# SITE INSPECTION REPORT

Ducie Street Manchester M1 2JQ  
BBL/1168/2022

**Inspection Type:** Drainage

**Inspection Notes:** Site visit to inspect below ground foul and S/W drainage.

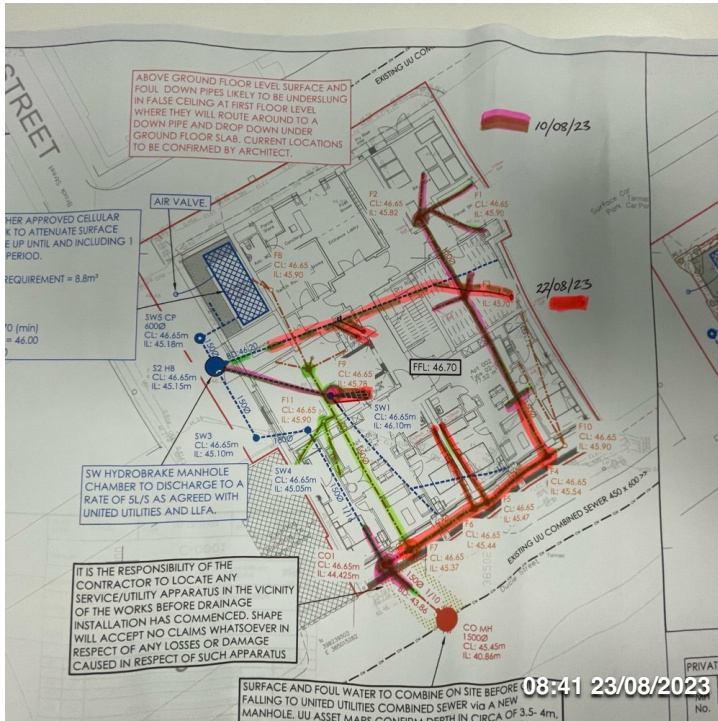
**Other Comments:** Photo evidence required for drainage run into S2HB that has been laid level, drainage run to be laid with adequate fall.

Photo evidence required for front elevation drainage when fully laid/supported by adequate bedding material (presently supported on blocks)
